Staff Report to the Planning Commission

Application Number: **05-0721**

Project Description:

Location: 2601 and 2515 Porter Street, Soquel

URBAN DESIGNER's COMMENTS:

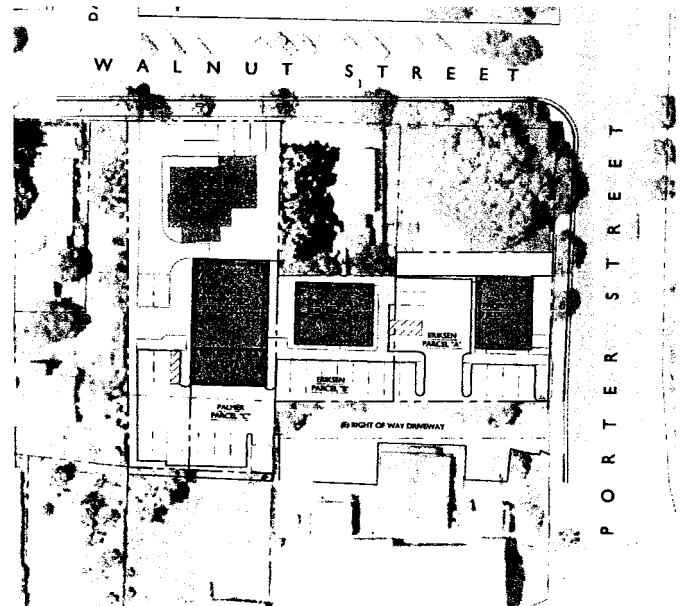
- *The proposed property line between Parcels A and B makes no sense on the ground. When one parcel is sold – how is liability and maintenance allocated when parking crosses over the property line?*

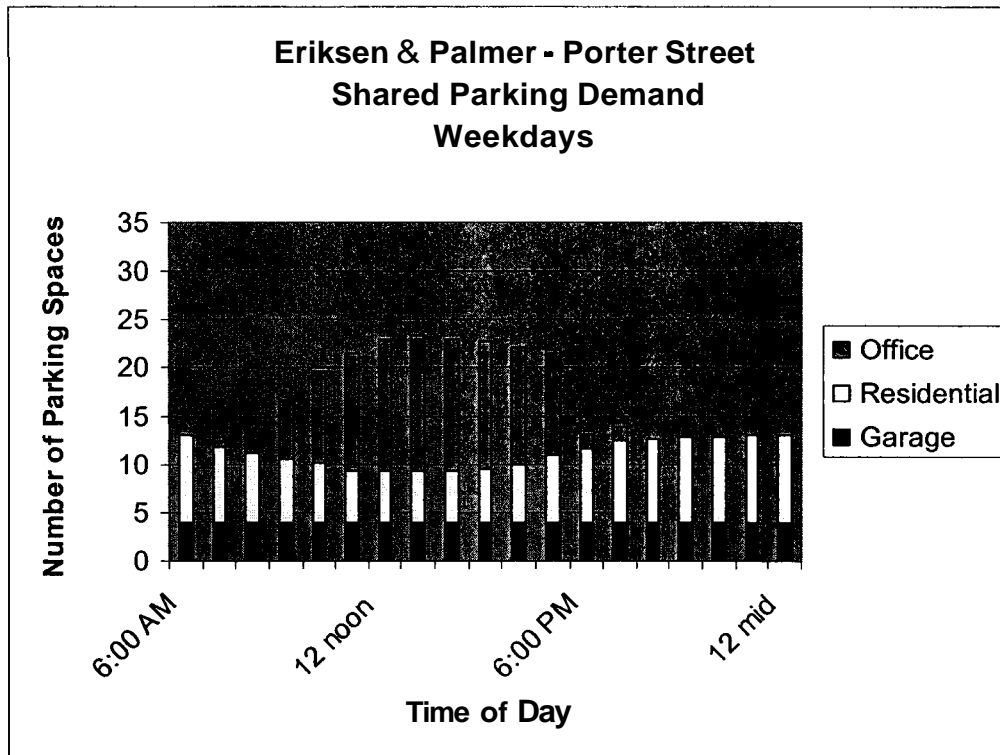
Comment: Residential and commercial parking areas should be separated. **Response:** One of the concepts of a mixed use development is to take advantage of the opportunity to share in the parking made available and thus reduce the need for excessive parking pavement. Parking access for residential and commercial uses will not pose safety issues in small developments. Separating residential and commercial parking spaces in a small development eliminates the potential benefits of shared parking.

Comment: Parking areas adjacent to building #3 appear to lack room to maneuver. **Response:** Both parking areas adjacent to building #3 as depicted by the composite plan submittal meet the County design standards as reflected in Section 13.11.074 "Access, circulation and parking" of the County Code.

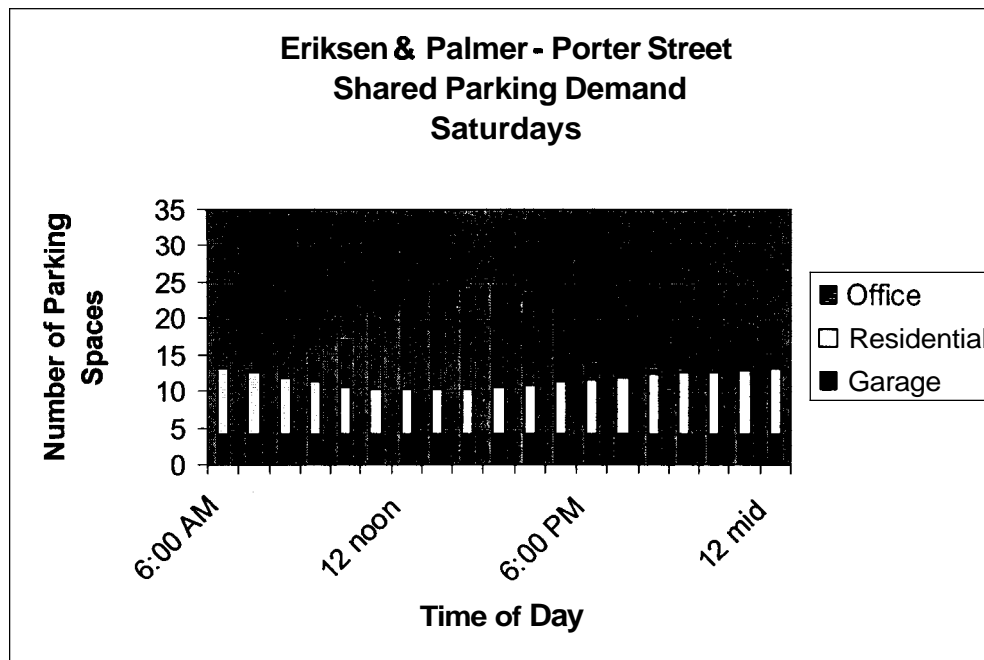
Comment: The proposed parking garage access and egress may conflict with circulation in the parking area. **Response:** The proposed parking garages do not pose potential safety concerns. Speeds in the parking circulation area will be relatively slow. The parking area is too small to allow speeds to build up. If this remains a concern the curb face adjacent to the garages could be extended by six feet to direct the parking circulation away from the face of the garages. This will further reduce speed within the parking area and increase the margin of safety.

Maximum parking demand 23 spaces 12 to 3 pm.

Maximum parking demand 25 spaces 3 pm.
